To: Honorable Mayor Patrick Collins and Members of the City Council
From: Morgan Dennis
Subject: PUDC-25-257 – Golden Meadows, 2nd Filing
Date: December 3, 2025

**GOLDEN
MEADOWS 2ND
FILING**

FILE: PUDC-25-227: Golden Meadows, 2nd Filing (Expedited Review)

REQUEST: Subdivision of a 4 large single lots into 8 lots.

**GOLDEN
MEADOWS 2ND
FILING**

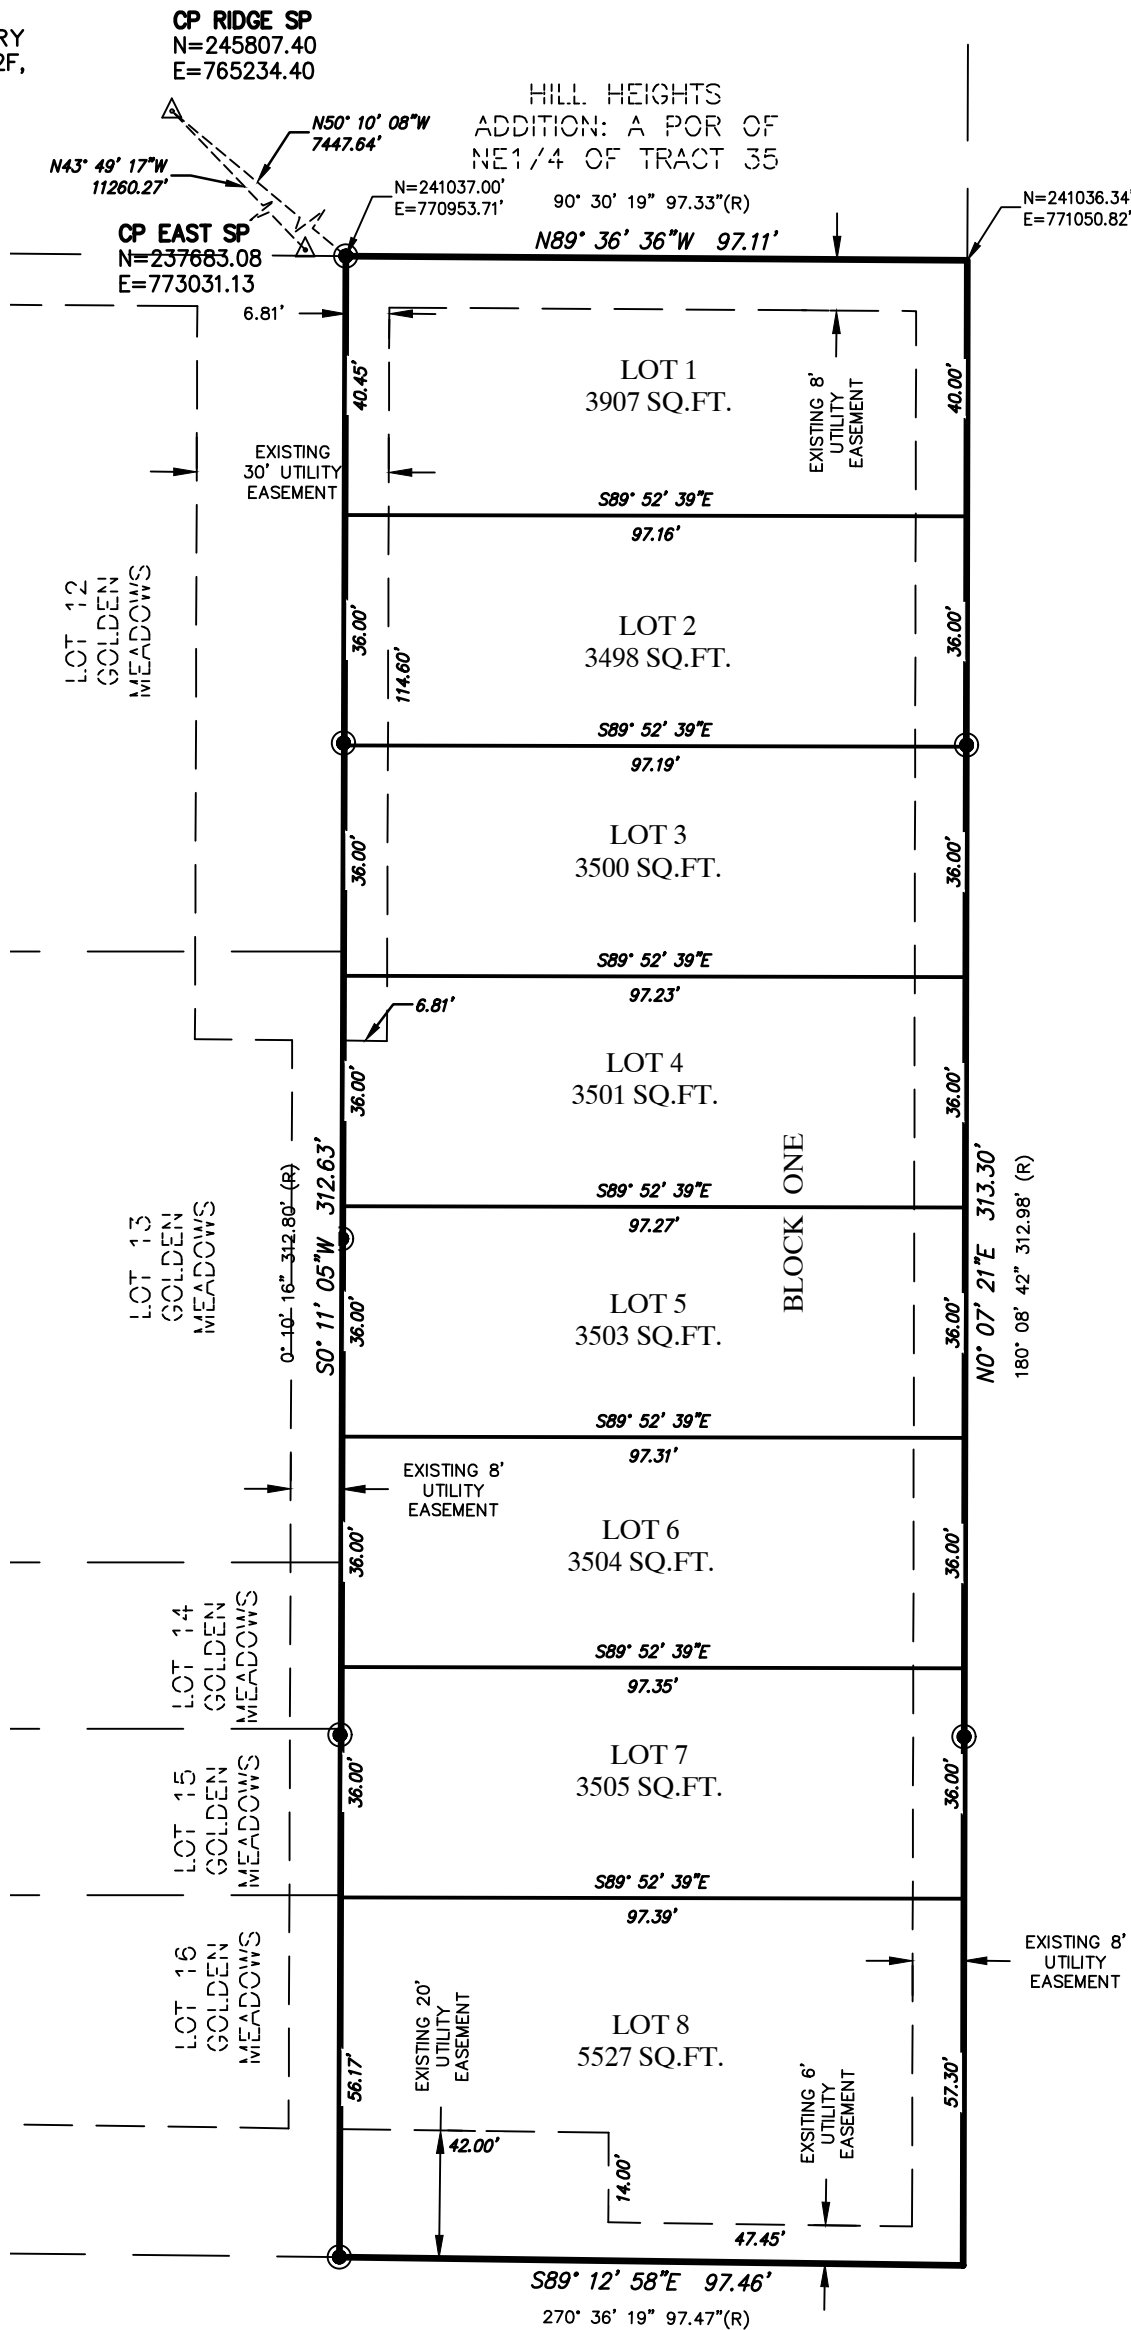
There will not be a vehicular access from Lot 8 to Dell Range Blvd. Dell Range is substandard in required width and this plat will need to dedicate an additional ten (10) feet of right-of-way on Lot 8 along Dell Range.

The approved plat needs to include an additional ten (10) feet of dedicated right-of-way on Lot 8 along Dell Range Boulevard.

1. Dell Range Blvd is a Principal Arterial and currently has 80' Right-of-Way adjacent to this development. Recommendation is to dedicate right-of-way to match the 100' of Right of Way on the east side of Connie Drive.

1. Acknowledgement
 - a. Reduction in rear setback of 10'.
 - b. Potential reduction in minimum dimensions for single-unit residential open space.
2. Exception:
 - a. Exception to block size.
3. Condition:
 - a. Prior to recording of the final plat, dedicate 10' of right-of-way to Dell Range Boulevard.
